LOTUS SERVICE BULLETIN

Class	III
Number	1970/13
Type	Europa
Date	1.4.1970.

Title: Radiator Cooling Fan.

Reason: Introduction of a new cooling fan, with reversed blade pitch, from Chassis No. 7003070089Q.

Fig. 1.

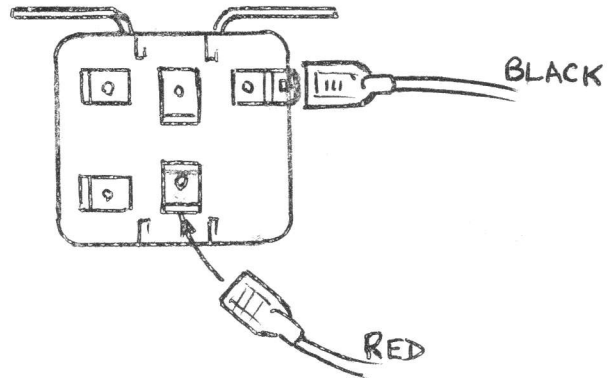
Action: Since the fan has blades of reversed pitch, to maintain the same direction of air flow the direction of rotation must be reversed. Therefore, when fitting the new fan, which is interchangeable with the earlier one, the motor connections to the fan relay must be reversed to conform with Fig.1. By operating the heater/cooling switch on the facia, check that the airflow is correct, i.e. is blown onto the front wheel. The new fan is easily distinguished from the earlier one by the shape of its blades which are rectangular and narrow. Consult the Workshop Manual, Section K.7, for instruction on changing the fan.
